# Application for Alternative Equivalent Compliance

## Application for Alternative Equivalent Compliance Narrative Describing the proposed Alternative Design

## Pre-Application Meeting for Rezone

Alternative Equivalent Compliance for landscaping

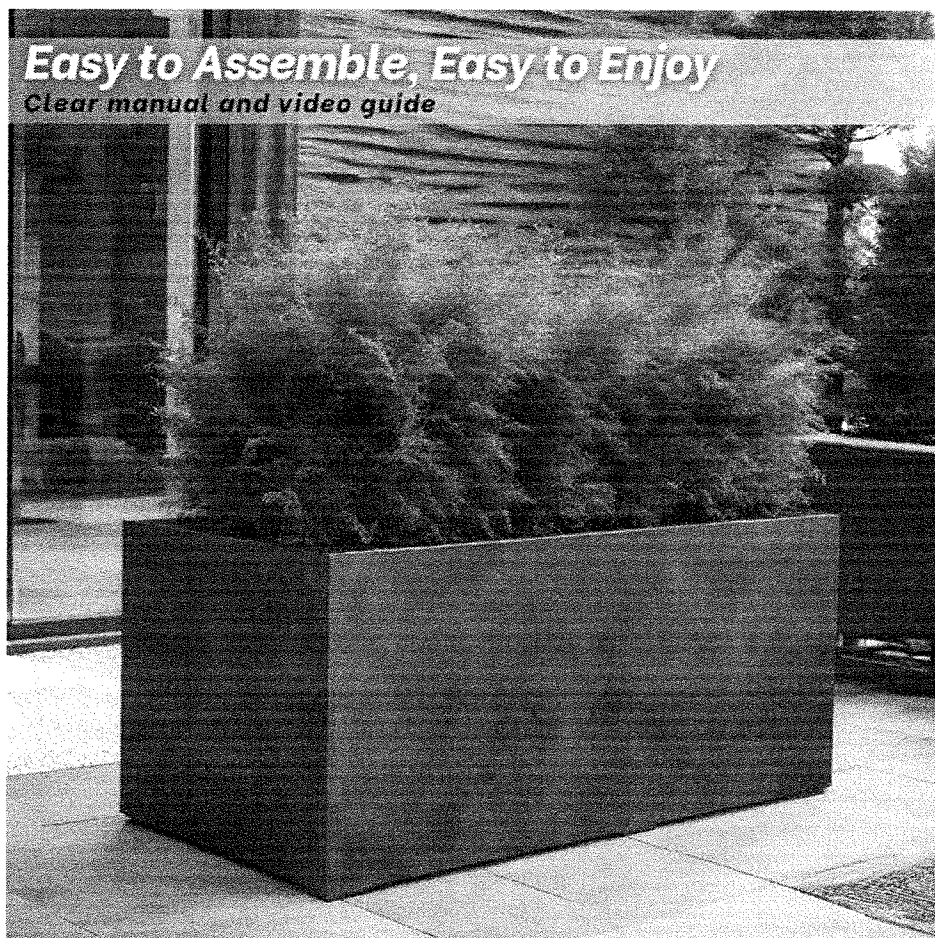
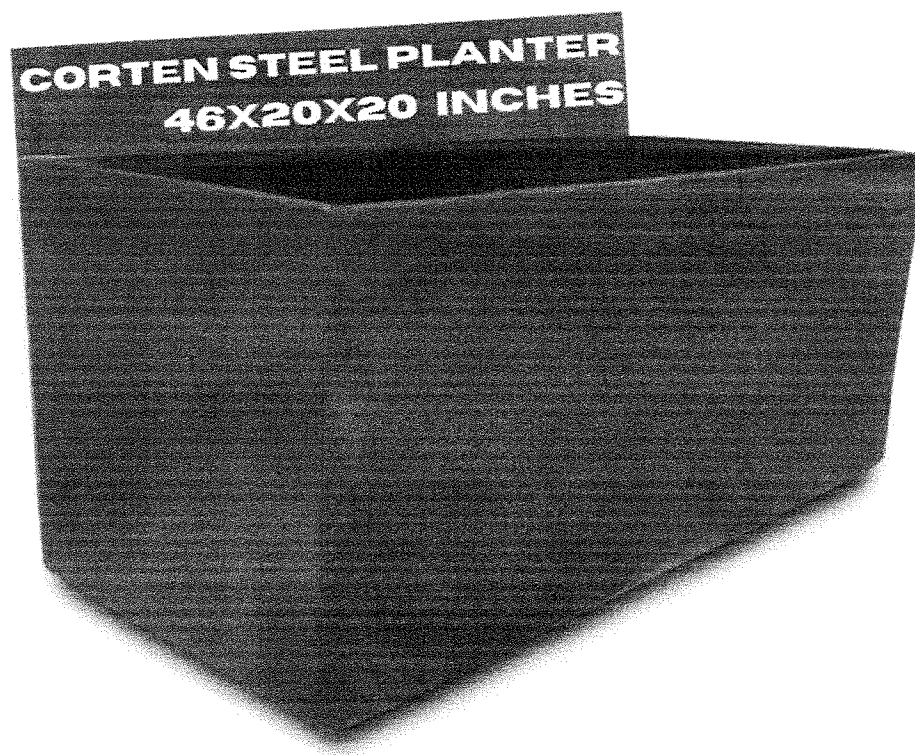
R) Concern regarding survivability of the plants in the containers. The possibility of it dying and having to replace it later. Nice to see this car wash get reused and changed to an office space.

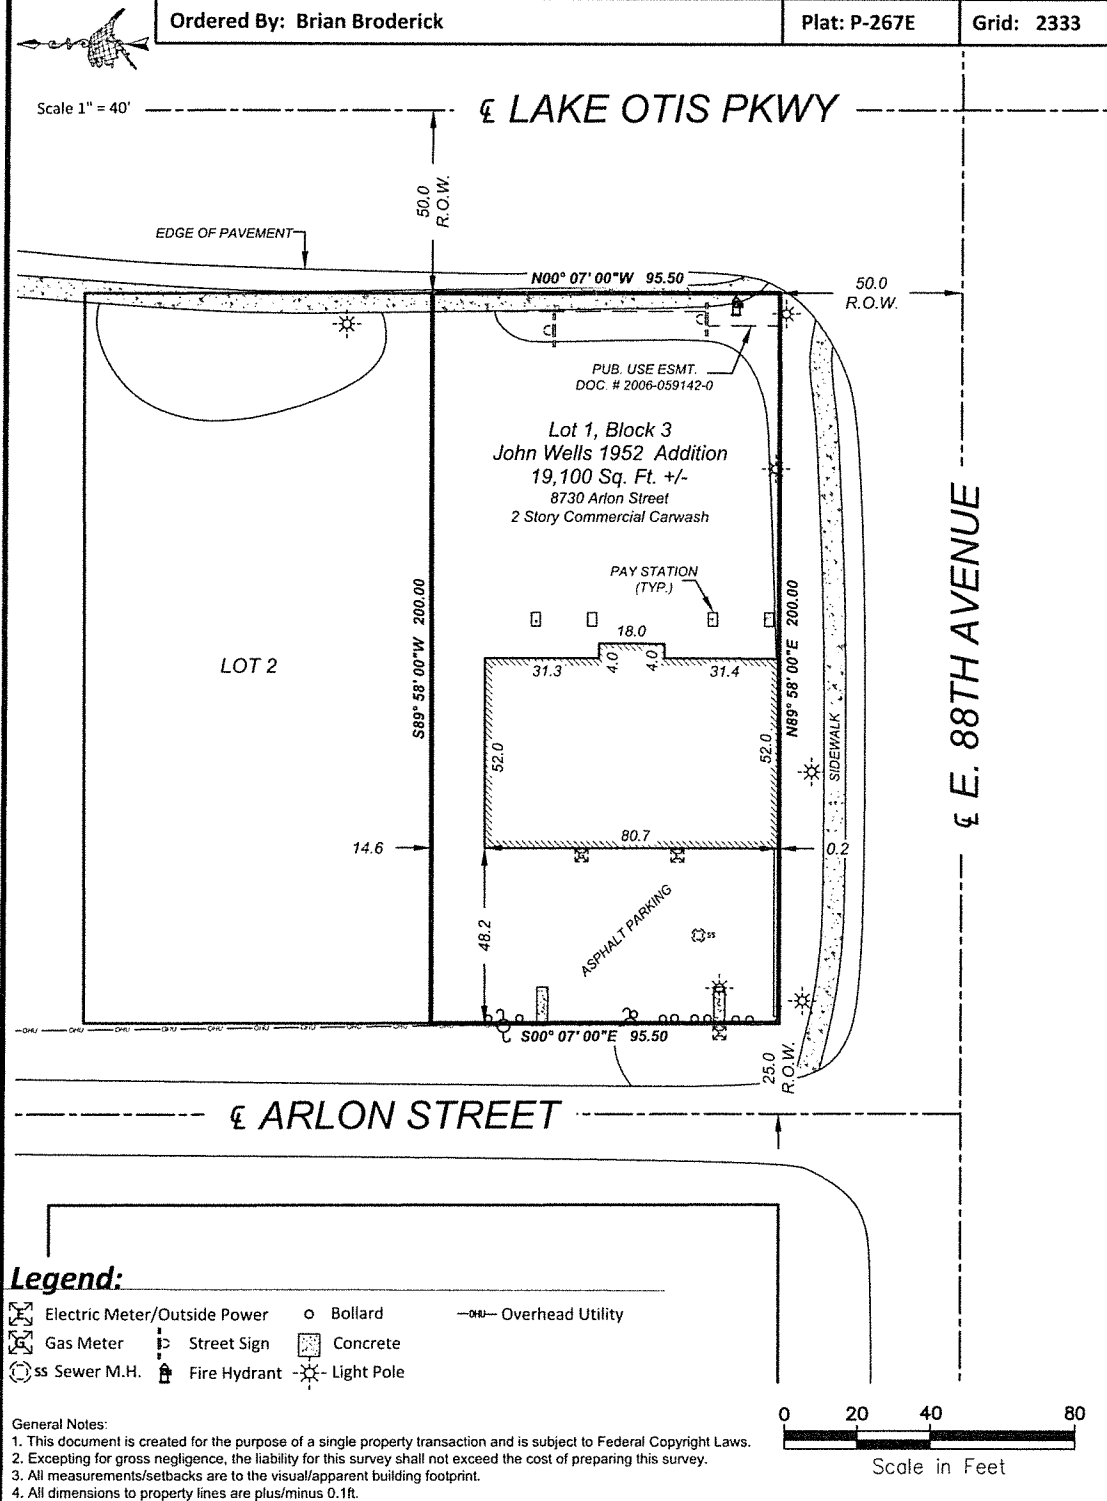
F) How are the planters equal to the required landscaping that you are proposing to replace. What is your plan for maintaining the planters.
